I received addendum No. 01, Dated November 30, 2016 for
Oregon County BRO-B075(1)
Project Job #3479

ADDENDUM NO. 1

DATE: November 29, 2016

FOR: OREGON COUNTY BRIDGE REPLACEMENT
BRO-B075(1)
GRE NO. 3479

C.R. 225 BRIDGE OVER FREDERICK CREEK (BRO-B075(1))
OREGON COUNTY, MISSOURI
GENERAL NOTES, QUANTITIES & DATA

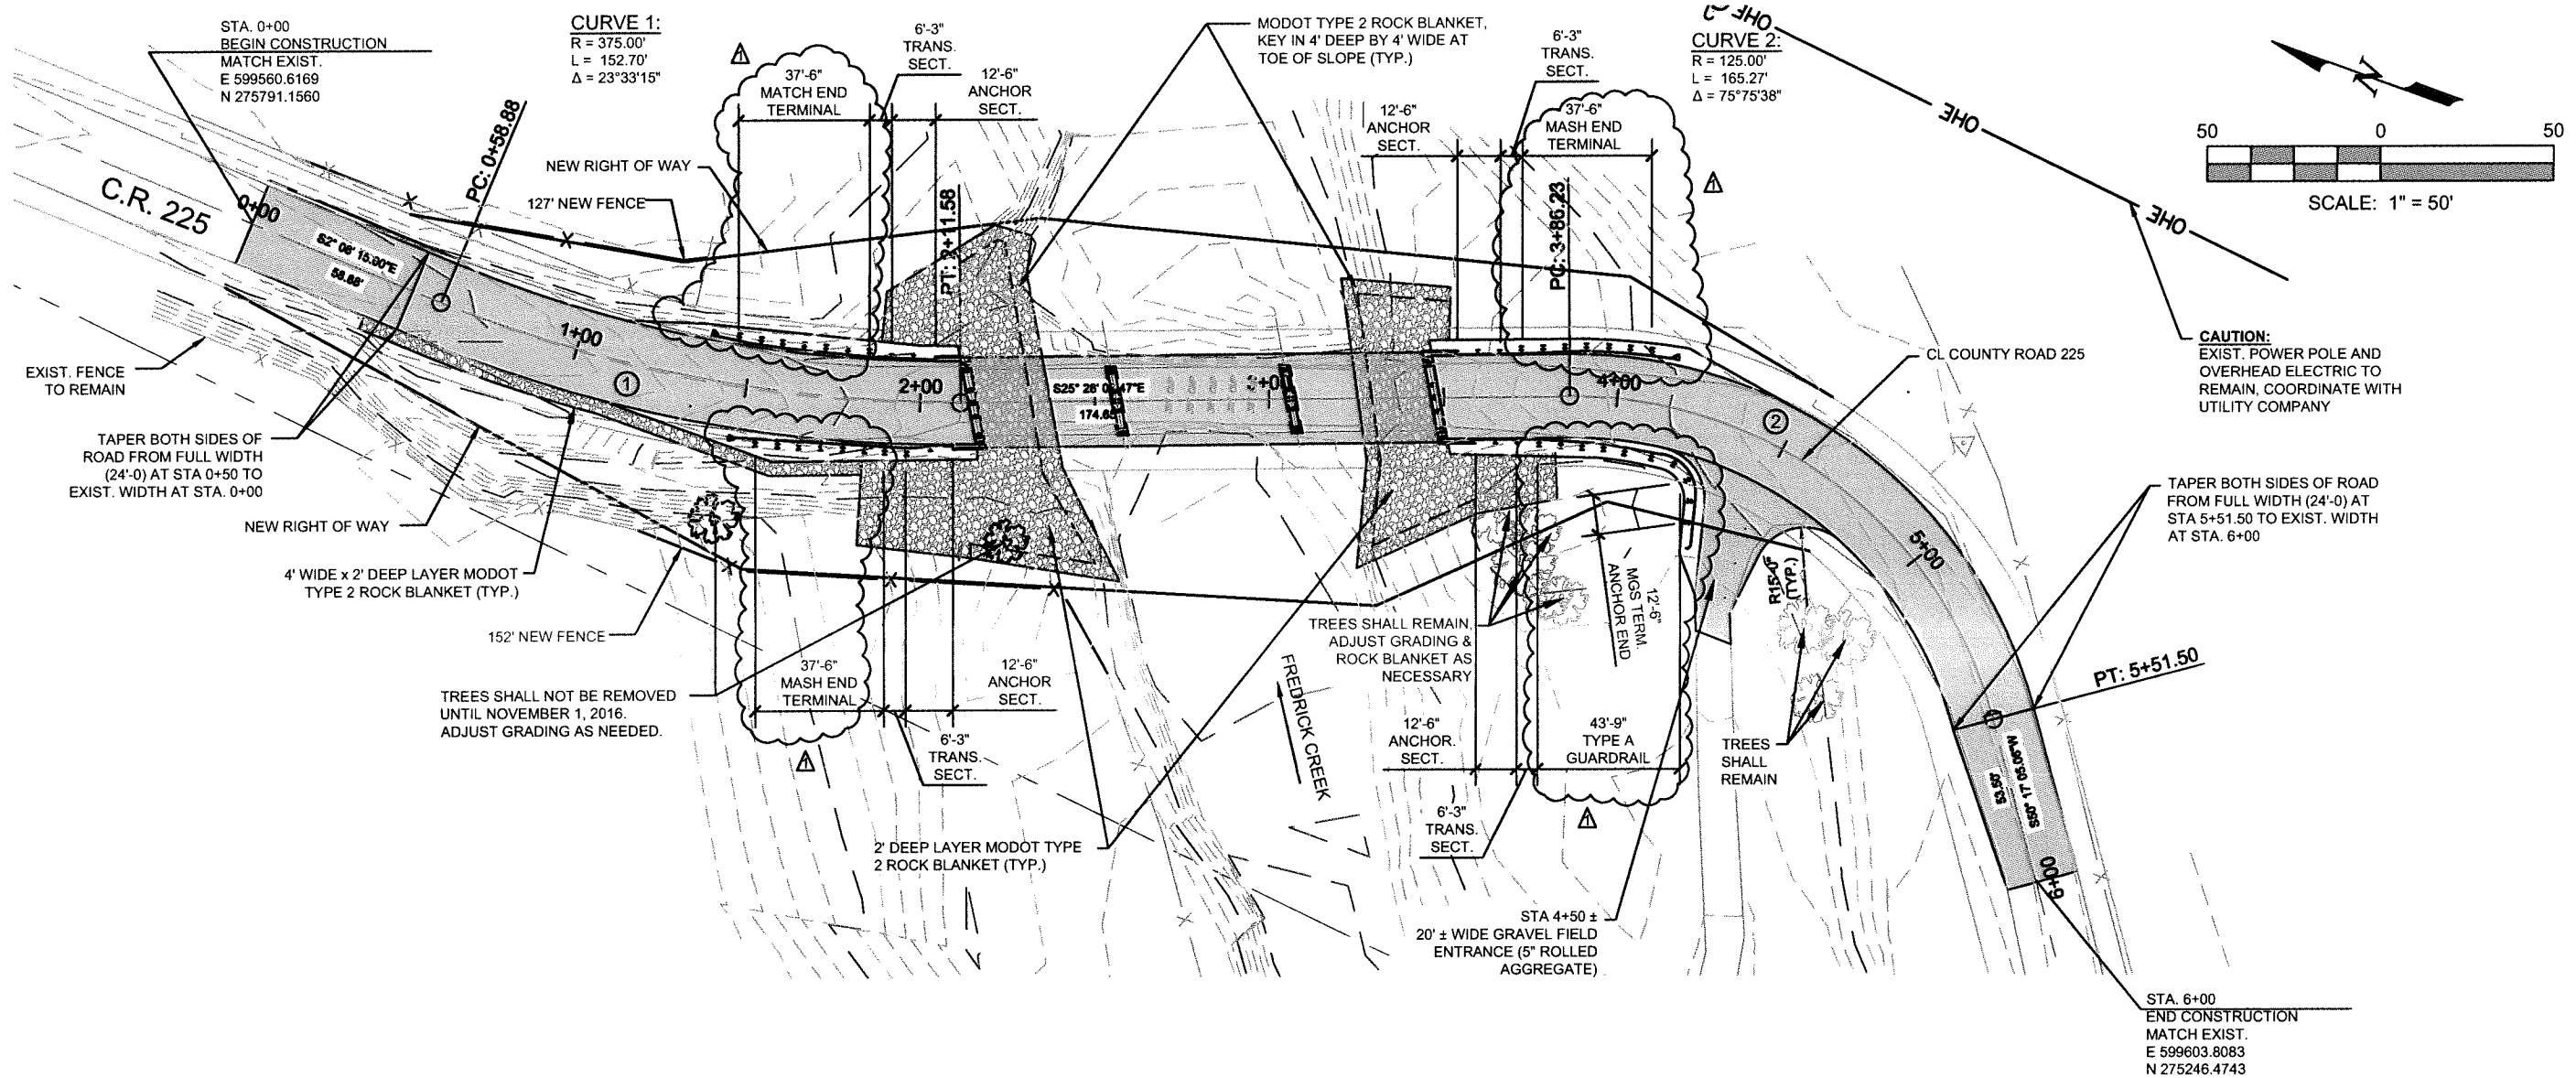
MASH End Terminals shall replace the Crashworthy End Terminal and a MGS Terminal Anchor End and Type A Guardrail shall be installed per the revised plans. Quantities have been revised due to these changes.

Date	11-29-18
Revision/Issue	REVISED GUARDRAIL

C.R. 225 BRIDGE OVER FREDERICK CREEK (BRO-B075(1))
OREGON COUNTY, MISSOURI
ROADWAY PLAN AND PROFILE

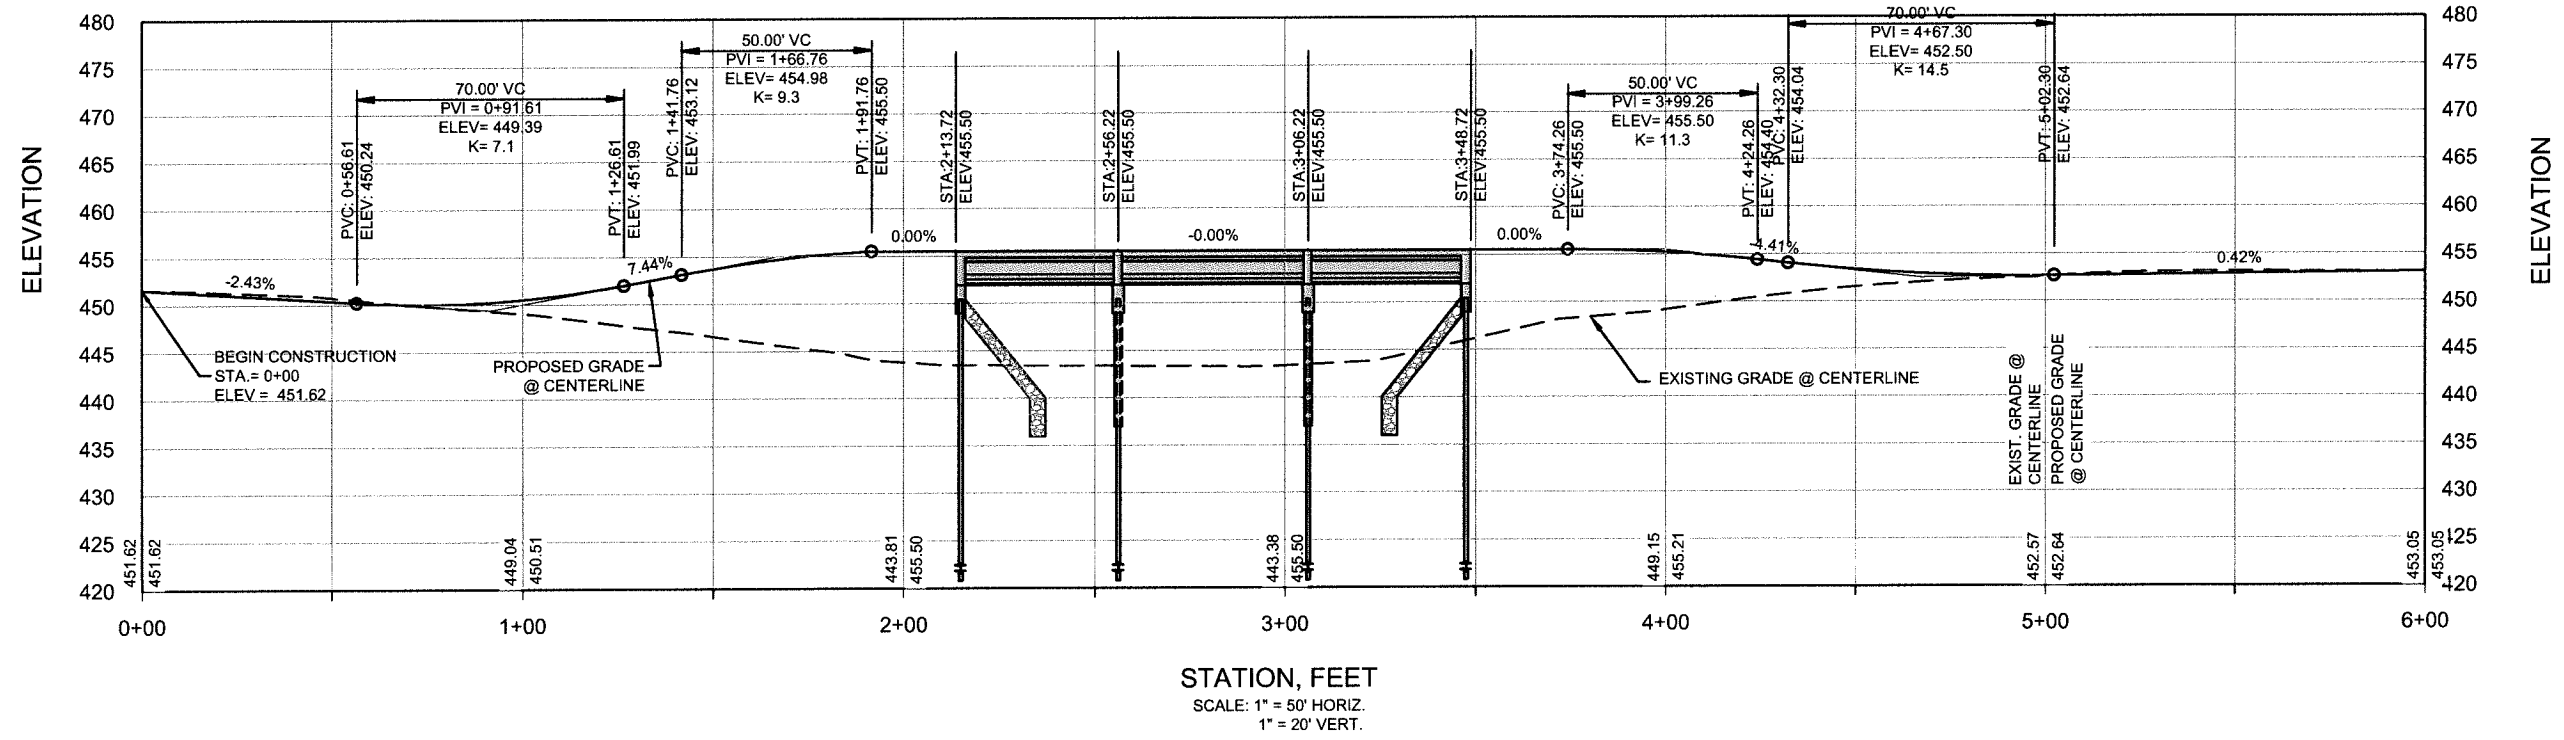
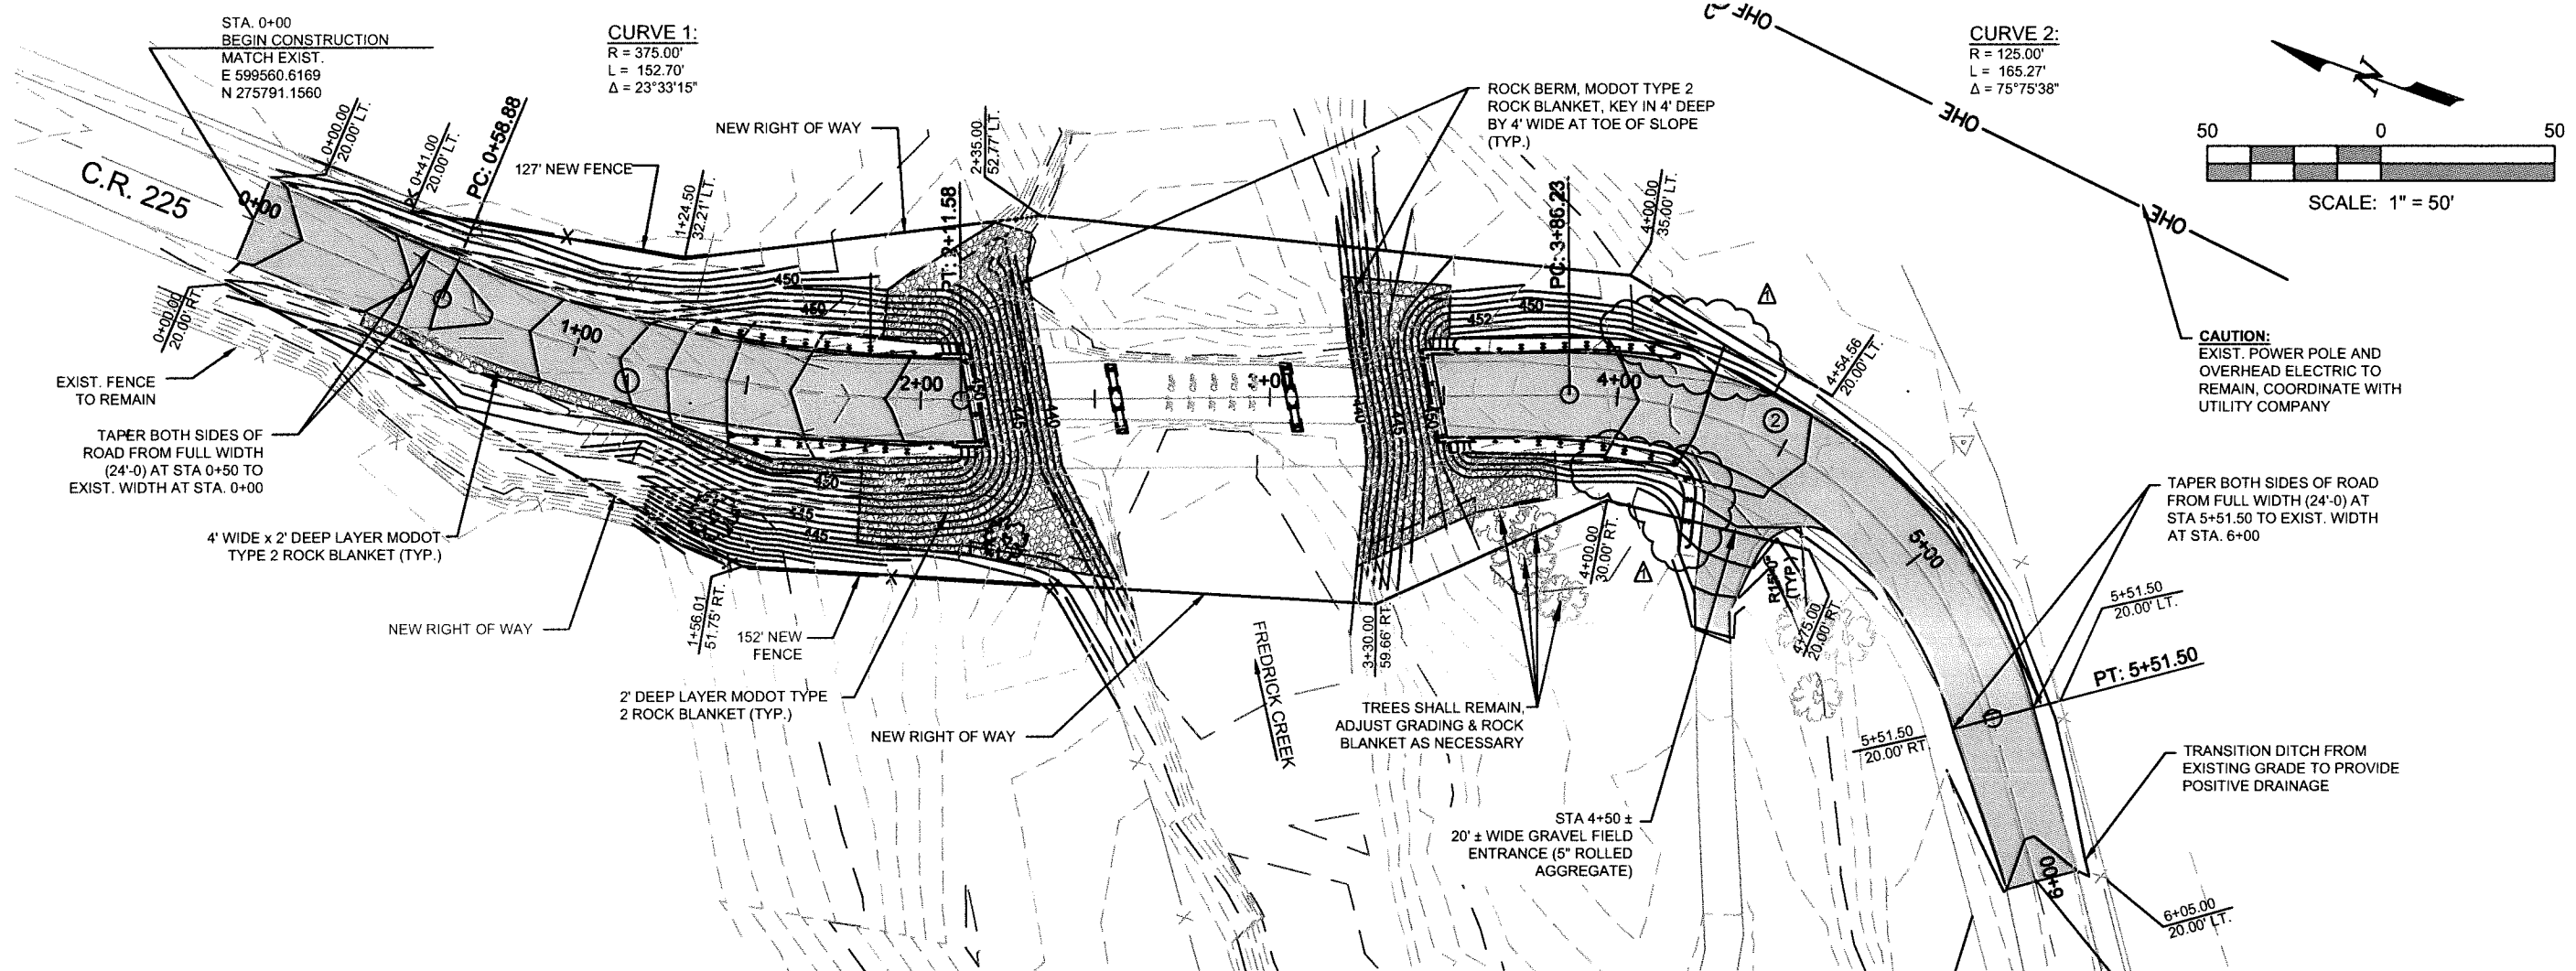
Date	11-28-18
Revision/Issue	REVISED GUARDRAIL
No.	1

C.R. 225 BRIDGE OVER FREDRICK CREEK (BRO-B075(1))
OREGON COUNTY, MISSOURI
GRADING PLAN & ROCK BLANKET LAYOUT

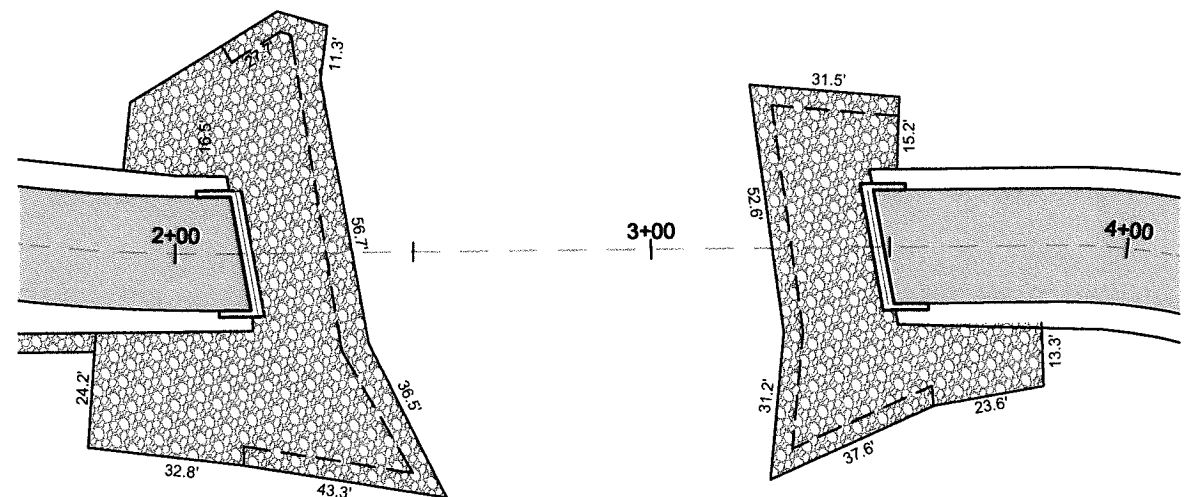
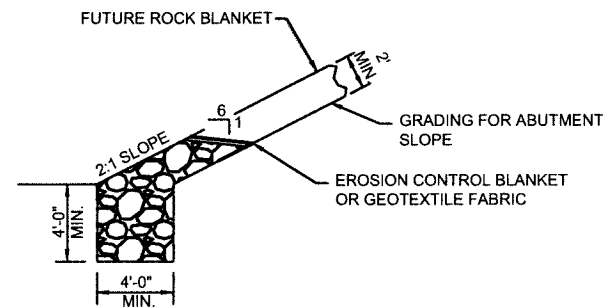
Date	11-29-18
Revision/Issue	REVISED GUARDRAIL
No.	1

C.R. 225 BRIDGE OVER FREDERICK CREEK (BRO-B075(1))
OREGON COUNTY, MISSOURI
CROSS SECTIONS

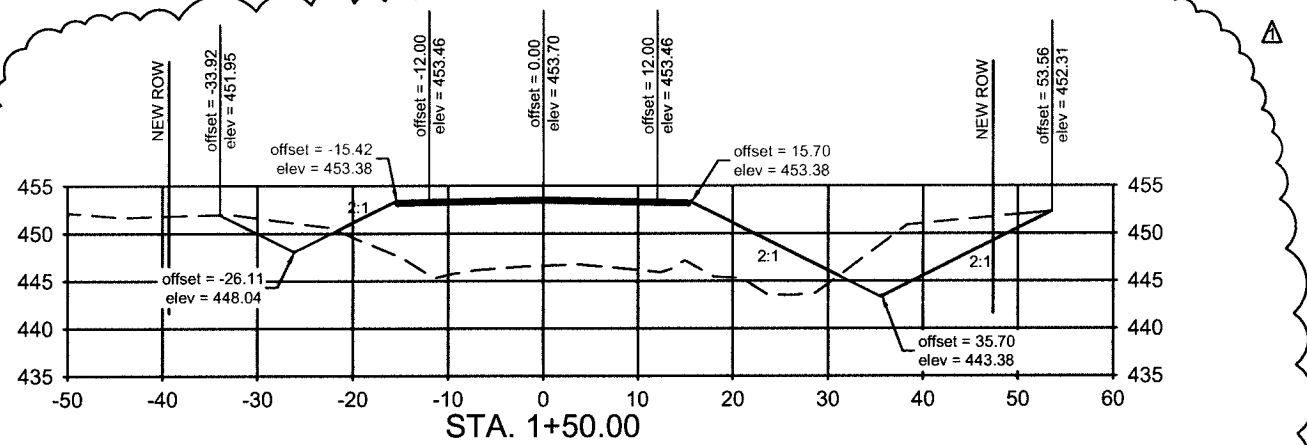
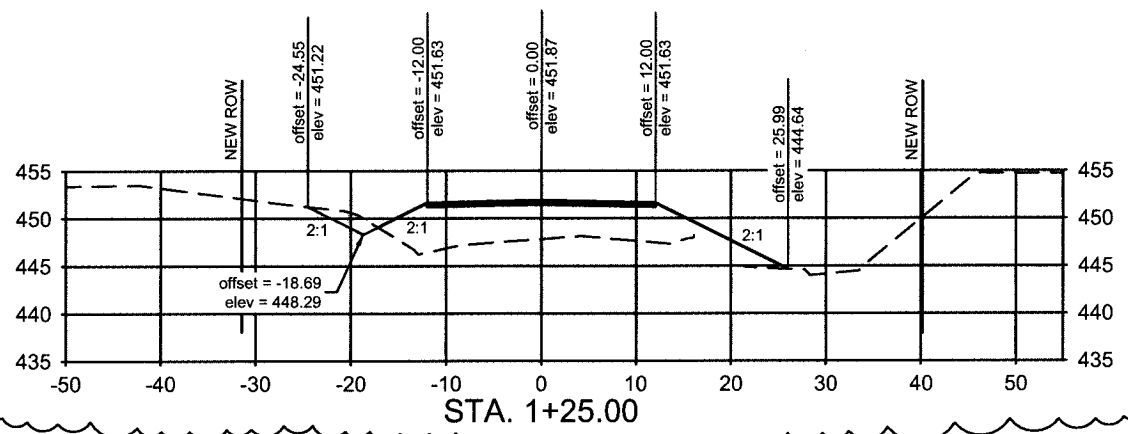
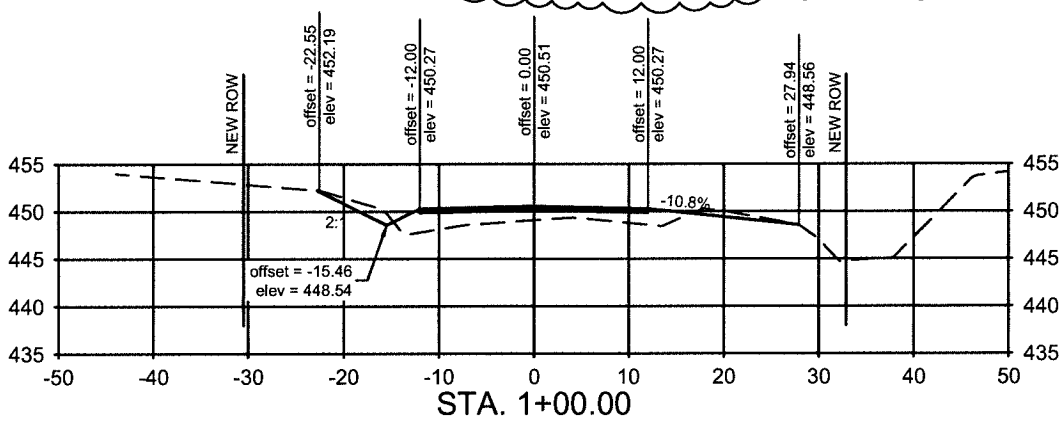
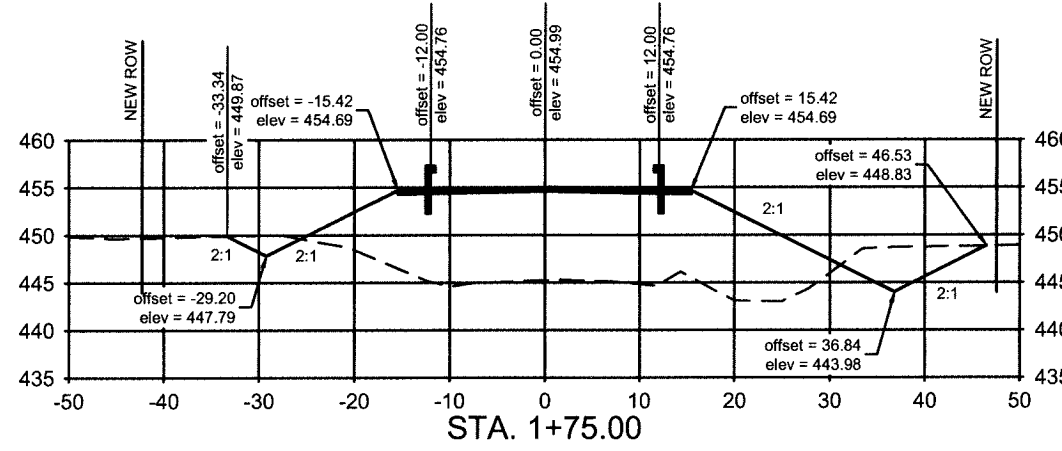
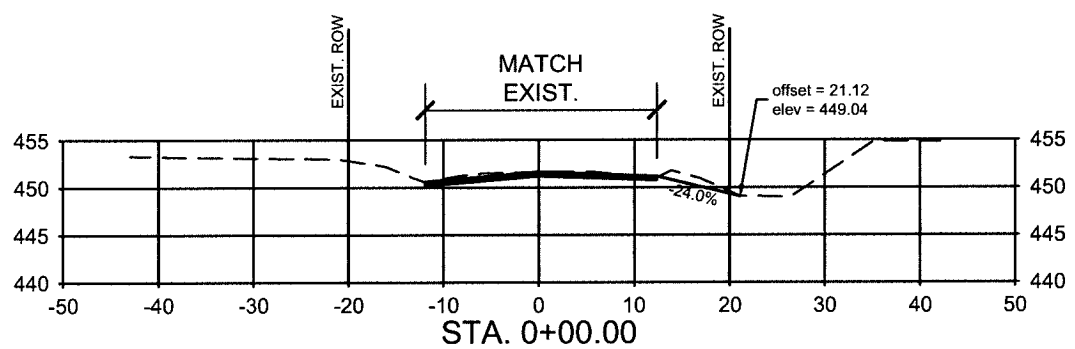
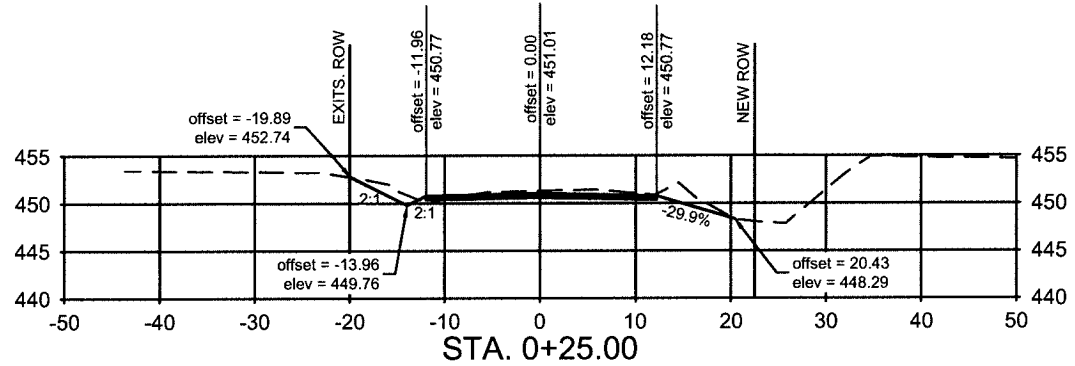
Date	11-28-18
Revision/Issue	REVISED GUARDRAIL
